Palmdale Hybrid Power PROJECT

Supplemental Responses to CEC Data Requests Set 1

Docket 08-AFC-9

**PALMDALE HYBRID POWER PROJECT (08-AFC-09)
CEC STAFF SET 1 DATA REQUESTS 28, 31 & 39 – 49**

Figure 5 Map 5/6
 Built Environment Technical Report
 PHPP
 Palmdale, California

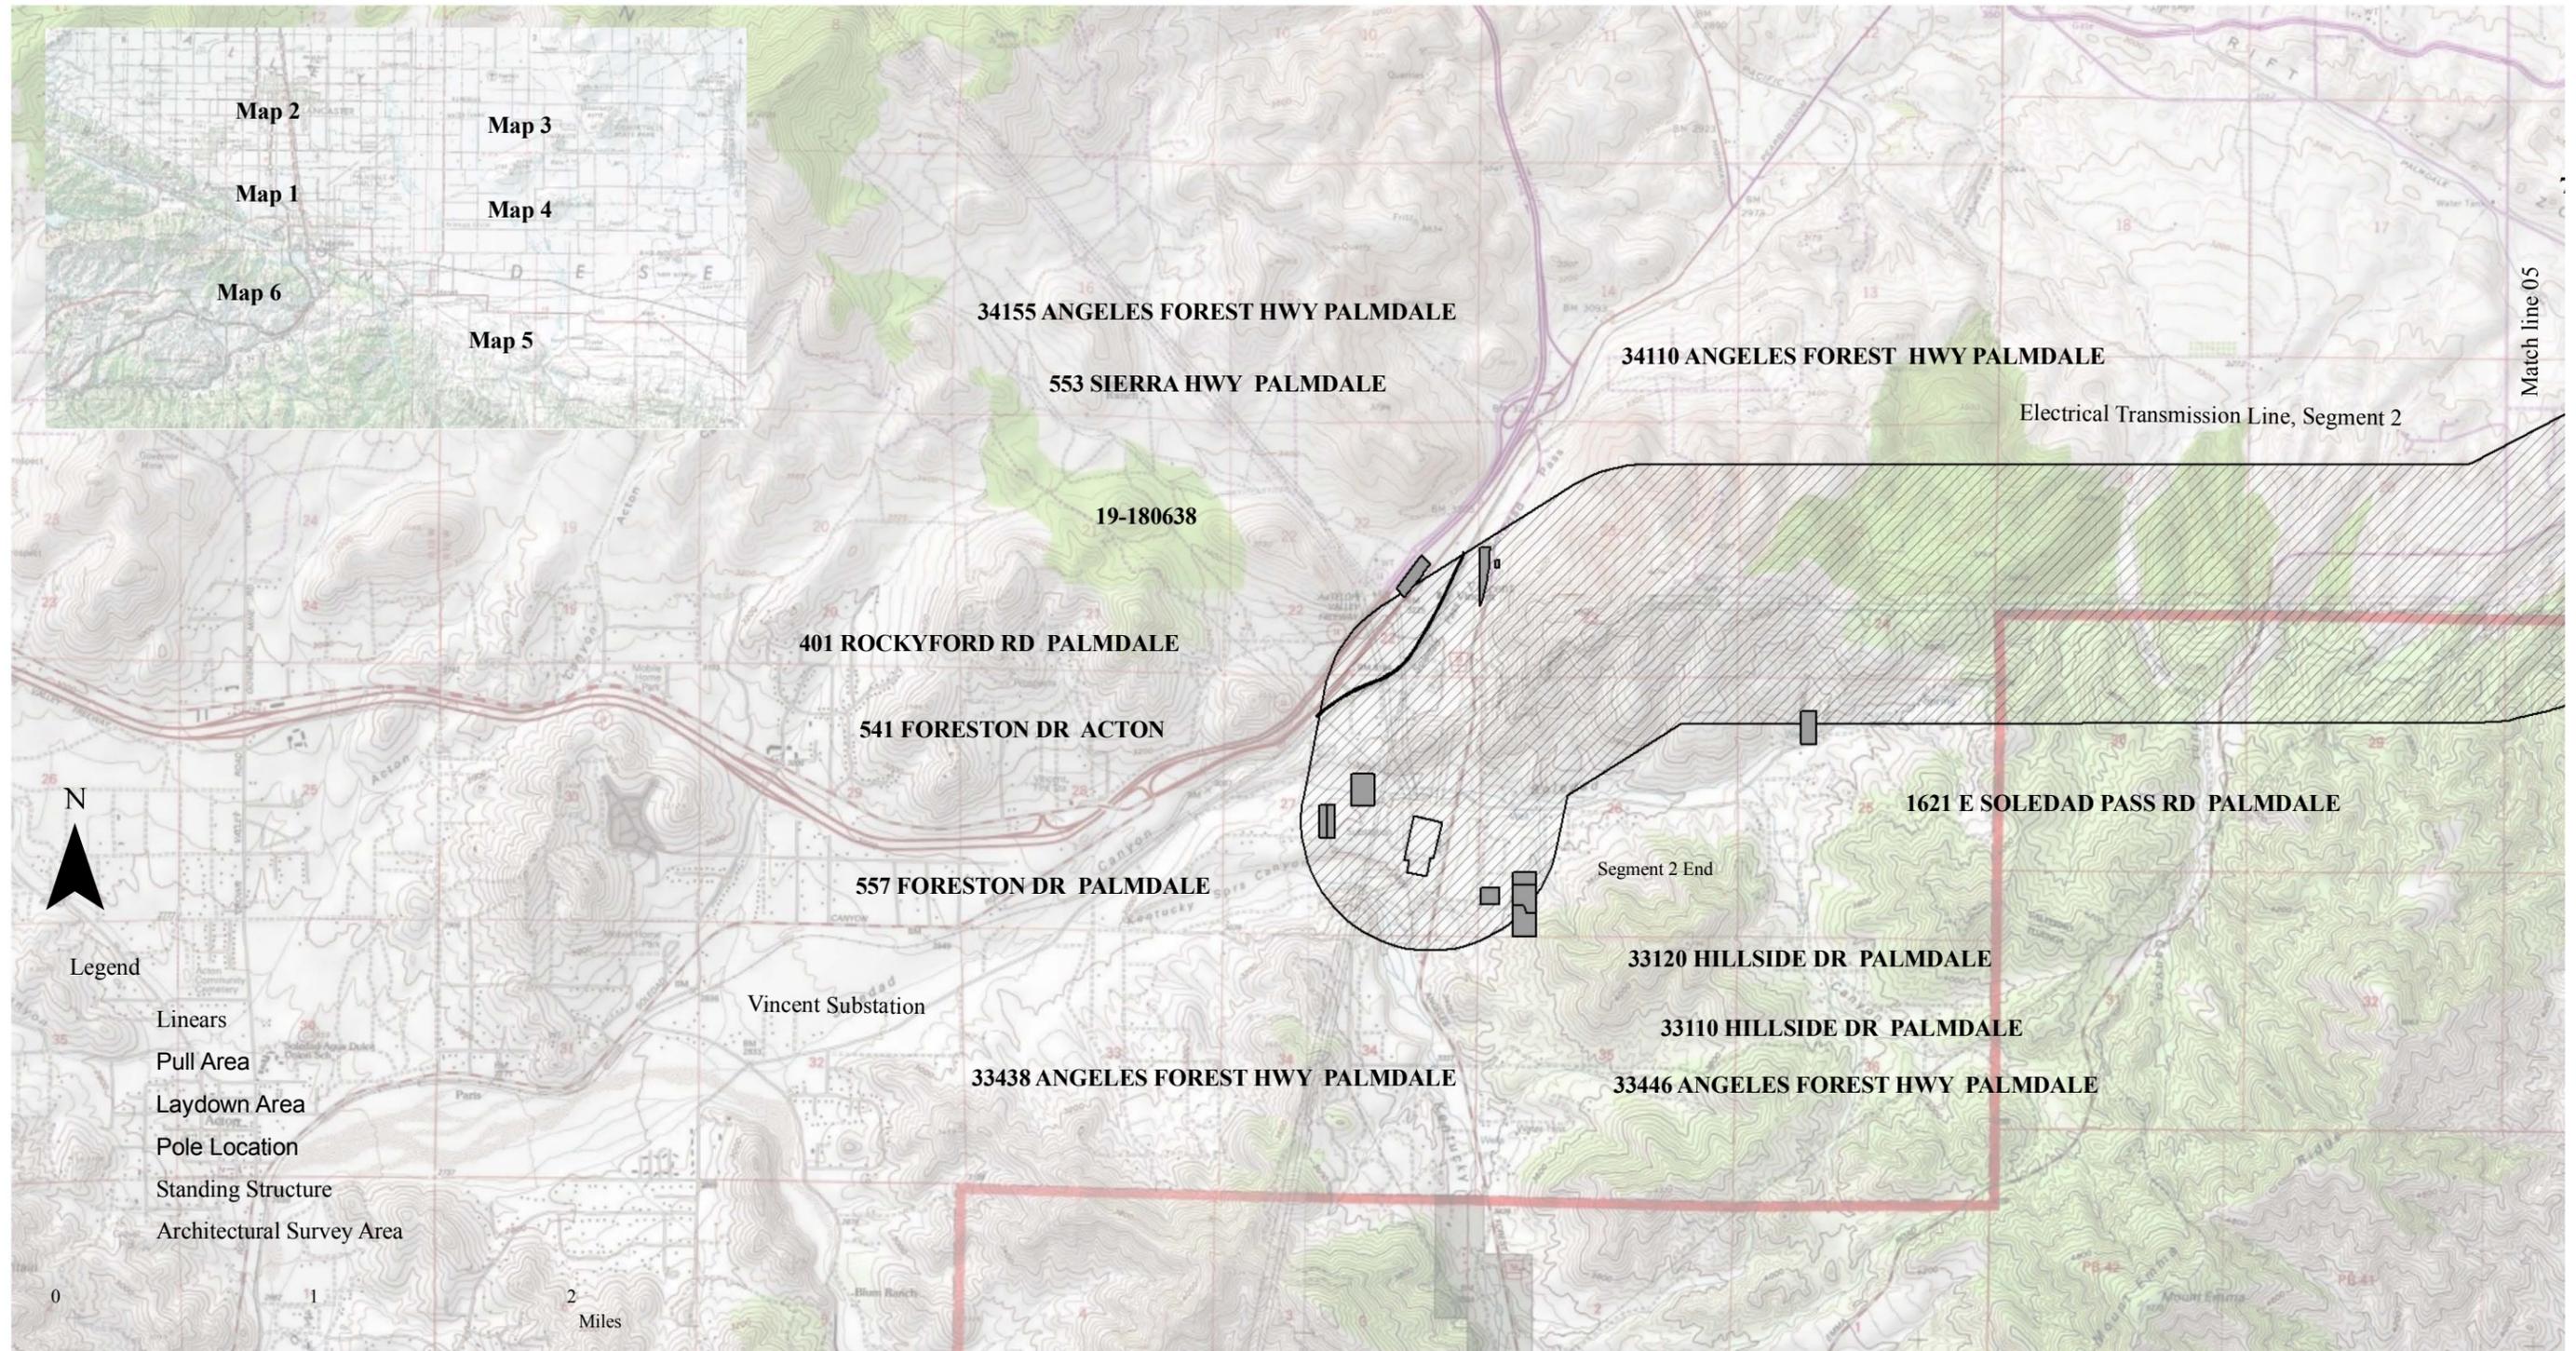
Please submit a new non-confidential Figure 5 which adds the tower locations and the pull site locations for the proposed transmission line to the plotted locations of known and newly identified built-environment resources.

The Applicant has revised the non-confidential version of Figure 5, which adds tower locations, pull site locations, and laydown areas for the proposed transmission line to the plotted locations of known and newly identified built-environment resources. The six maps comprising Figure 5 are included as an attachment at the end of this section.

The two transmission line reroutes (see response to Data Request 20), the three laydown areas, and the 22 pull site locations are all within the built environment survey area, so no new built environment surveys will need to be conducted. One of the pull sites extends into Parcel AIN 3027007002, which is outside of the original built environment surveys area. This parcel has been added to the survey area, but is vacant according to the County Assessor's data, so it will not be re-surveyed.

Changes to the Transmission Line route

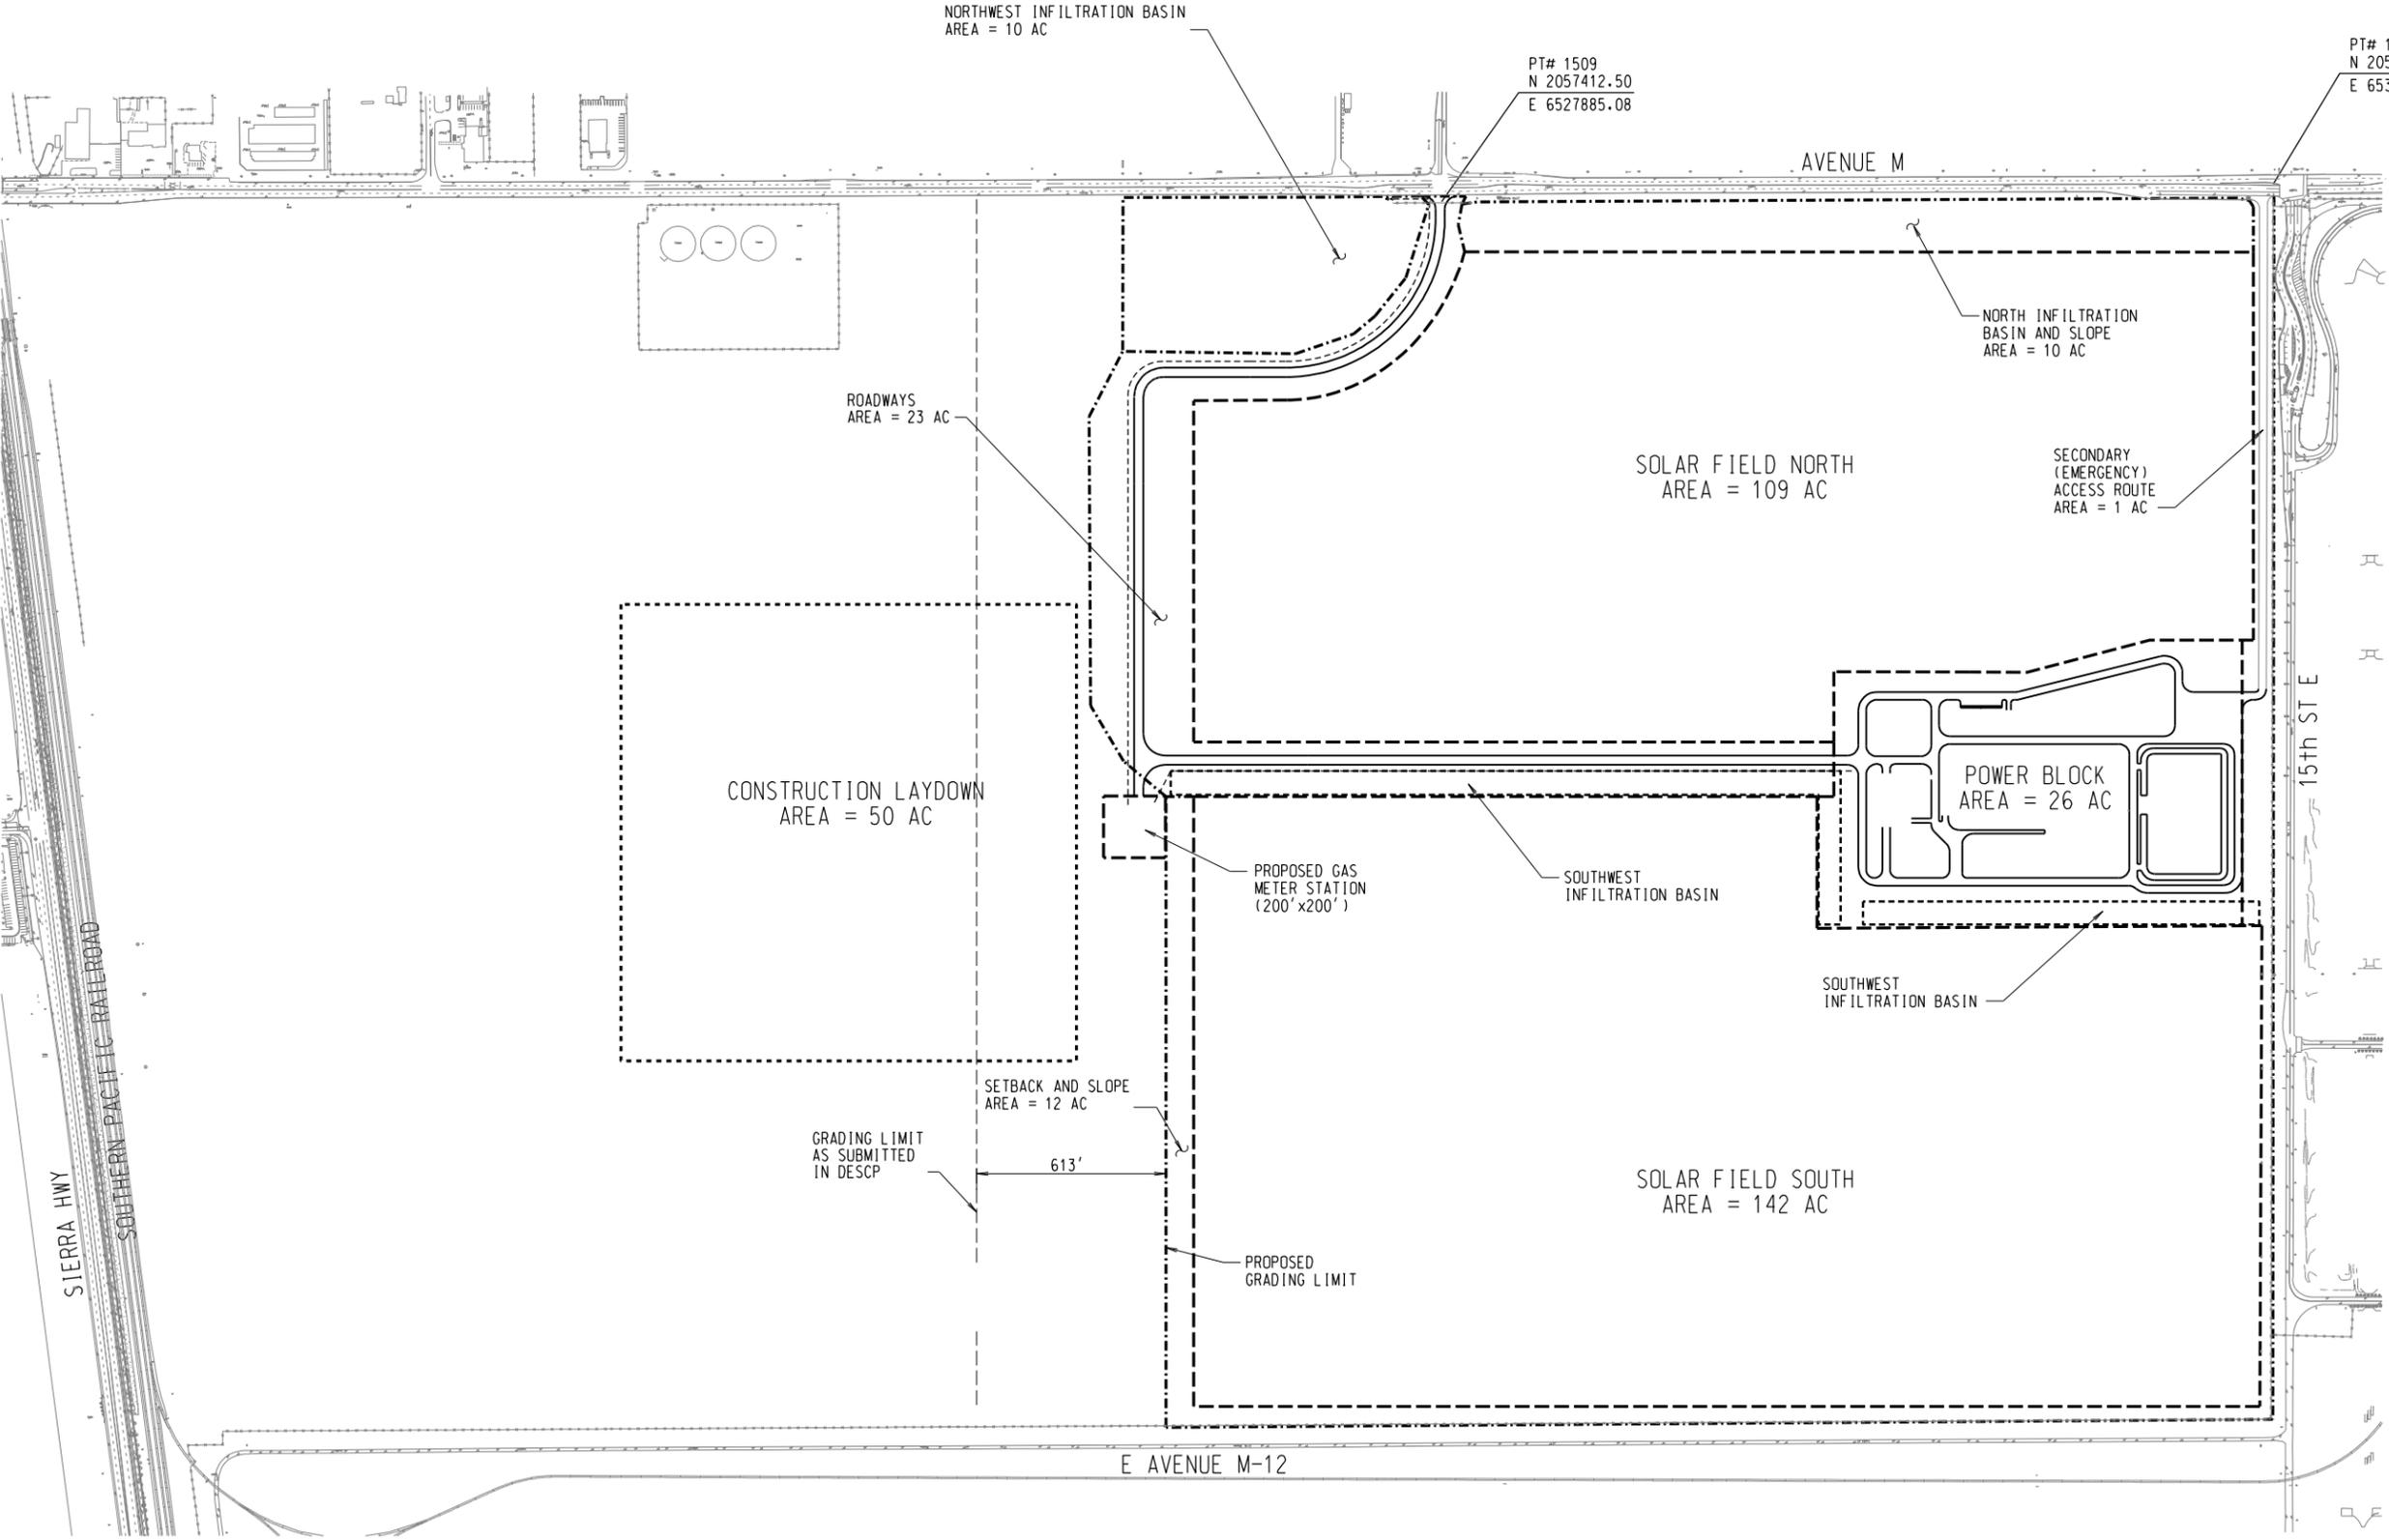
CEC Data Request Set 1 included a request to provide specific pole locations for the transmission line. It also requested additional information on the pole locations, spur roads and related facilities in relation to washes and other streambeds. Further discussions with Southern California Edison (SCE) and more detailed engineering to address these requests have caused changes to be made to the proposed alignment near the beginning of and at the end of Segment 2 of the transmission line from the way it was originally depicted in the AFC.

Originally the transmission line was to enter the Vincent Substation on the north side of the facility. The administrative and control buildings are clustered on the north side of the Vincent substation and SCE would not allow the PHPP transmission lines to cross over these structures to the switchyard on the south side of the substation. The newly proposed alignment has the transmission line now running south down E. Soledad Pass Road, then south and west on Hillside Drive into the substation from the south.

Additionally, the transition from Segment 1 to Segment 2 of the transmission line into the Pearblossom switchyard is along Lone Oak Rd. The transmission line will still roughly follow Lone Oak Rd., but is now slightly further north, outside of the corridor previously surveyed for cultural resources.
